Code changes for pools, tubs and spas

The 24th edition of the *Ontario Electrical Safety Code (OESC)*, which becomes effective May 1, 2009, introduces significant changes to Section 68, *Pools, Tubs and Spas*, including the introduction of new installation requirements for splash pads and requirements for pool bonding.

Figure 2- Requirements for pool bonding

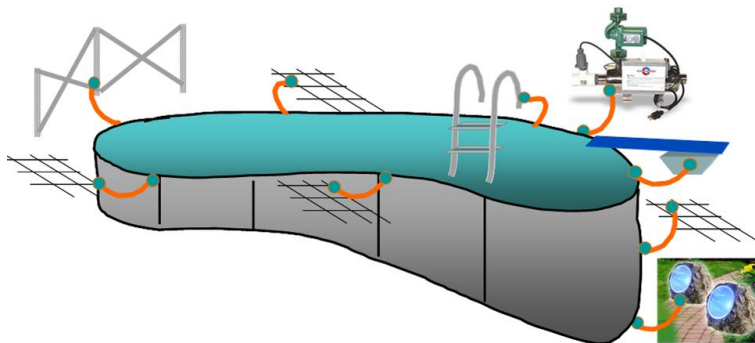
Rule 68-058 has also been amended. It requires metal parts of the pool and other non-electrical equipment (metal piping, pool reinforcing steel, metal ladders, diving board supports, fences, etc.) be bonded together, and to the non-current carrying metal parts of the associated electrical equipment (Figure 2). Prior to the new code, metal pool parts were not required to be bonded to the electrical equipment if the latter was more than 3 m (9.8 ft) away from the pool. This provision has been deleted.

Other changes include new Subrule 68-058 (8), which relaxes the requirements for a copper loop around a metal pool. The revision will only require a continuous metal pool shell, made up of individual panels that are securely bolted or welded together, be bonded in at least one location.

Figure 3 – Minimum clearances for conductors over swimming pools

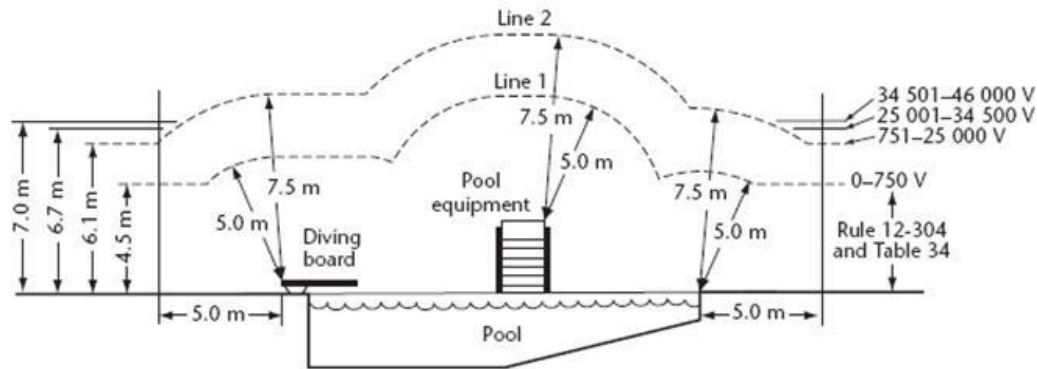
Rule 68-054 has increased the overhead wiring clearance to 5 m (16 ft) from the pool. The previous code required a clearance of only 3 m (9.8 ft). The following sketch (Figure 3) illustrates the minimum clearances for conductors over swimming pools and is located in Appendix B of Rule 68-054. No conductors would be permitted under any circumstances in the area under line 1. In the area above line 1, insulated communication conductors and neutral supported cables operating at 600 V or less might be permitted per 68-050 (2) and (3). Any other conductors, operating at not more than 50 kV, might be permitted above the area outlined by line 2 per 68-054 (2) and (4).

Figure 4 – A receptacle for a cord-connected hydromassage bathtub

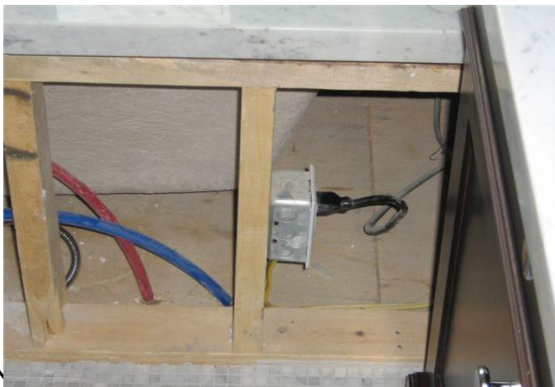
The location of the receptacle for a cord-connected hydromassage bathtub is covered under the new Rule 68-306. This requires one receptacle to be located at least 0.3 m (1 ft) from the floor and must be inaccessible to bathers in a bathtub (Figure 4). It also requires the appropriate warning label, supplied by the bathtub manufacturer, to be affixed to the receptacle, warning against connecting any other equipment to the receptacle. The warning label is not required where a single receptacle is used.

Figure 5 – Emergency shut-off switch

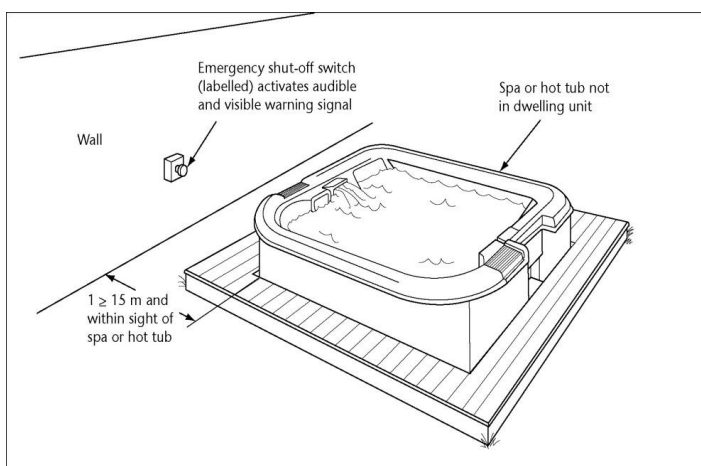
Emergency shut-off switch to be installed for each spa or hot tub, except for residential spas and hot tubs. The emergency shut-off switch, which must be independent of the spa controls, is designed to disconnect the motor's power source to the closed water circulating systems. The switch must be readily accessible to the user, be within 15 m (49.2 ft) of the spa or hot tub and be labelled in a permanent manner as the 'emergency' shut-off switch. The switch must also be equipped with audible and visual trouble-signal devices to give an immediate warning it has been activated. The emergency shut-off switch is also an Ontario Building Code requirement for public spas.
